Access Compliance Report

Public Rights-of-Way

(Curb Ramps)

Intersection ID: 27530	Main Street: BALLANTYNE_COMMONS_PY	Cross Street: BALLANTYNE_FOREST_DR	Location: NE
ADA ID: 5F70736128FE	Ramp Type: Perp	Initial Pass/Fail: Fail	Overall Compliance: No
Severity Score: 8.75			
Codes/Mitigation Info/Possible Solution		Field Measurements/Component Compliance

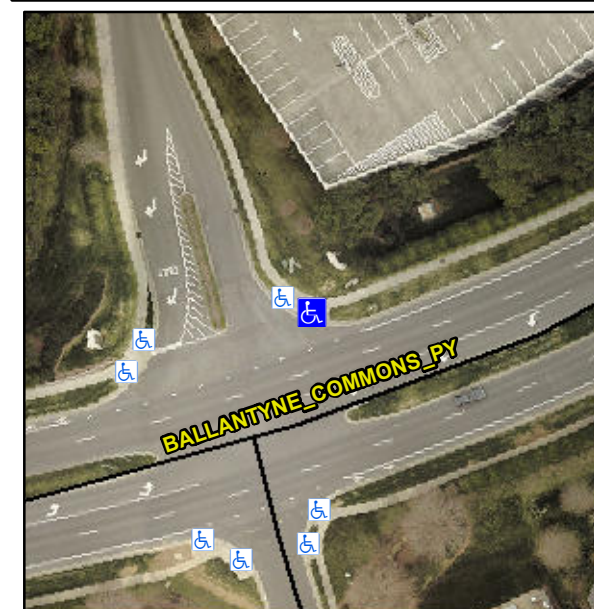
Not Found, R304.5.1

Compliance	Description	Data	Compliance	Description	Data
N/A	Ramp Length (in)	129.5	Yes	Ramp Slope (%)	7.3
No	Ramp Width (in)	46.5	Yes	Ramp XSlope (%)	1.3
N/A	Flare Type LT	N/A	N/A	Flare Type RT	N/A
N/A	Flare Slope LT (%)	N/A	N/A	Flare Slope RT (%)	N/A
N/A	Flare Traversable LT?	N/A	N/A	Flare Traversable RT?	N/A
N/A	Landing Length (in)	N/A	N/A	DWS Provided?	N/A
N/A	Landing Width (in)	N/A	N/A	DWS Contrast?	N/A
N/A	Landing Slope (%)	N/A	N/A	DWS Length (in)	N/A
N/A	Landing X Slope (%)	N/A	N/A	DWS Full Width?	N/A
N/A	Landing Curb? (Y/N)	N/A	N/A	DWS Offset (in)	N/A
N/A	Shared Landing?	N/A			
N/A	Gutter Ponding?	N/A	N/A	Gutter Slope (%)	N/A
N/A	Gutter Lip Ht (in)	N/A	N/A	Gutter X Slope (%)	N/A
N/A	Painted X Walk1?	No	N/A	Painted X Walk2?	N/A
	X Walk 1 Direction	To S		X Walk 2 Direction	N/A
N/A	X Walk 1 Width (in)	N/A	N/A	X Walk 2 Width (in)	N/A
	X Walk 1 Slope (%)	3.7		X Walk 2 Slope (%)	N/A
	X Walk 1 X Slope (%)	1.4		X Walk 2 X Slope (%)	N/A

Remove & Replace Entire Ramp.
